SUBJECT: Arkansas Nuclear One - Unit 1
Docket No. 50-313
License No. DPR-51
ANO-1 Second 10-Year Inservice
Inspection Program Relief
Request Submittal

ASME CLASS I COMPONENTS
NDE INSERVICE INSPECTION RELIEF REQUESTS
FOR ANO-1 BASED ON ASME SECTION XI-1980
CODE THROUGH WINTER 1981 ADDENDA

FIGURE 1

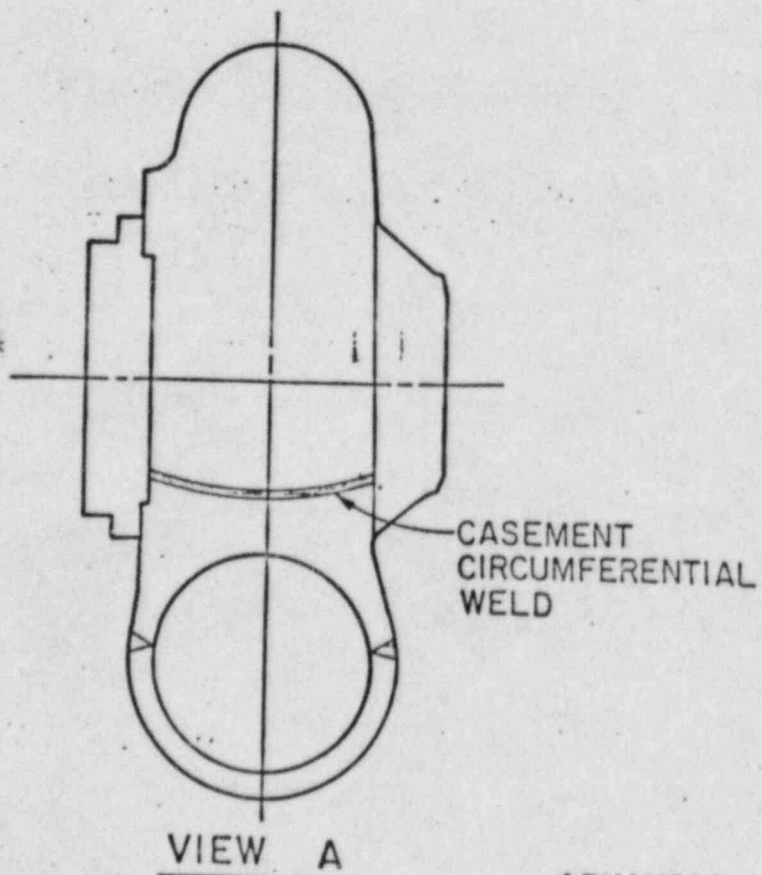
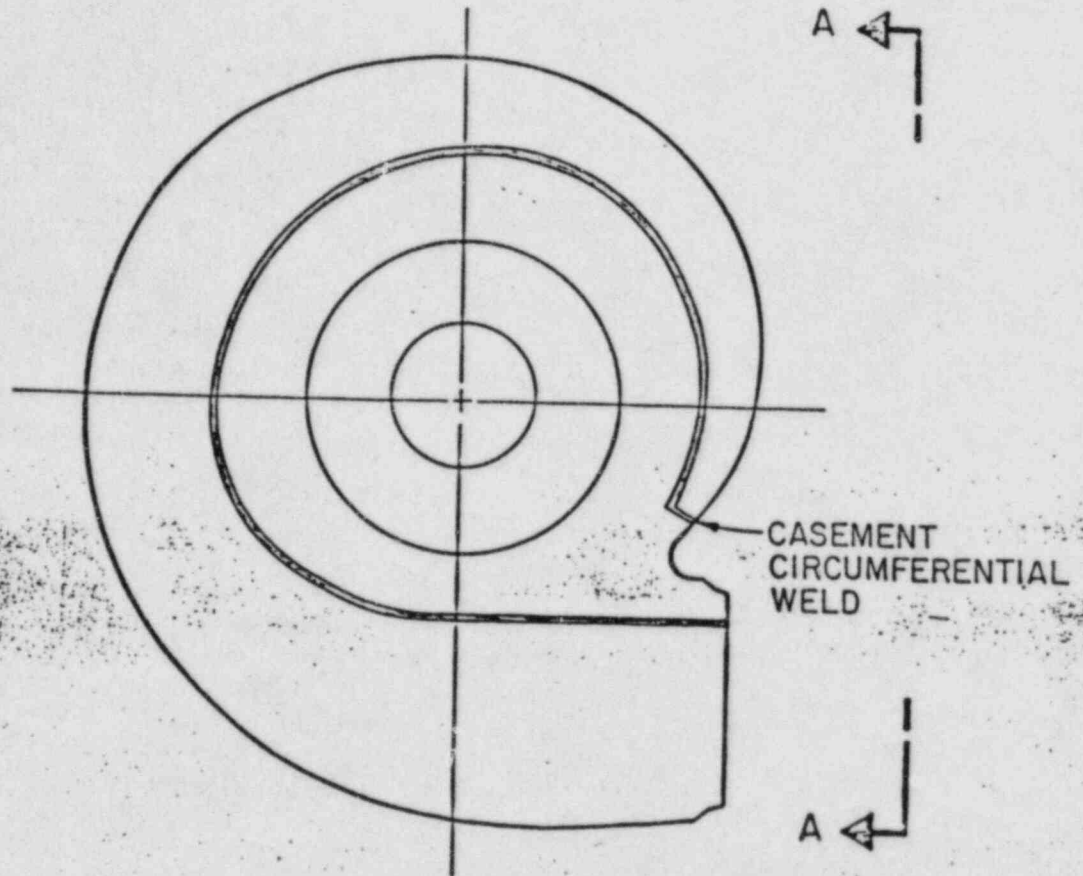
IWB-2500-1 ITEM NO.	EXAMINATION CATEGORY	SYSTEM OR COMPONENT	AREA TO BE EXAMINED	IMPRACTICAL CODE REQUIREMENT	REASON FOR REQUEST	LICENSEE PROPOSED ALTERNATE EXAMINATION
B12.20	B-L-2	Reactor Coolant Pump Pressure Boundary	Pump Casing Internal Pressure Boundary Surfaces.	Visual	Pump casing internal surfaces are inaccessible without dismantling the pump.	Partial surface repli- cation obtainable from casing weld volumetric examination.
